NDE reliability issues

Industry perspective and action plan

NRC Public Meeting May 30, 2012 White Flint

Response to NRC Concerns

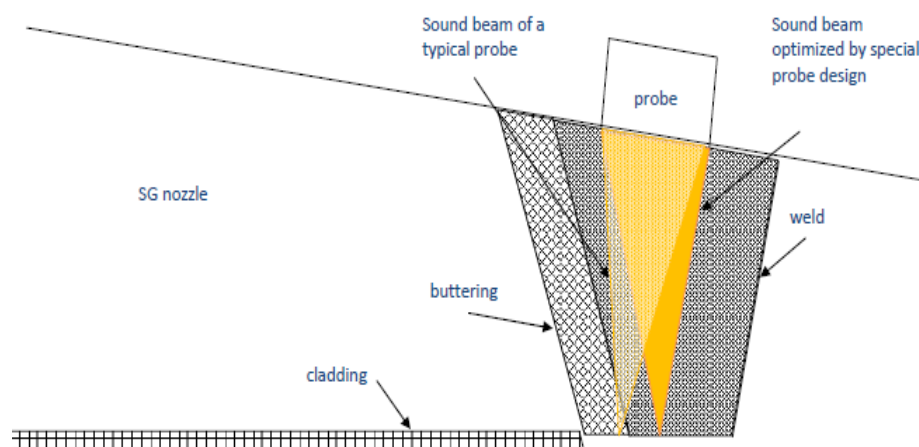
- *The second issue is possible variable quality probes. Neither the qualification process, nor the site specific mock up have provisions for acceptance testing or evaluation of purchased probes. Additionally, the probes were designed to be used in one scanning direction only, but a lack of prominent warnings or ergonomic indicators provided an error trap for inspectors who might not recognize that they are applying the probe contrary to the intent of probe design.*

- Industry Response to Concern 2
 - Current industry procedures require that the search unit angle be within 3° of what is specified
 - The ability to detect and correctly position the flaws within the site specific mock-up is a additional verification that the search units are within the design parameters
 - The documentation provided by the manufacturer clearly denotes which scan direction the search units were designed for
 - Actions
 - Additional guidance for verifying critical parameters during the receipt inspection and calibration of complex search units
 - Industry guidance documents will be revised to include recommended practices with regards to use of complex search units including the use of indicators to potentially reduce human error
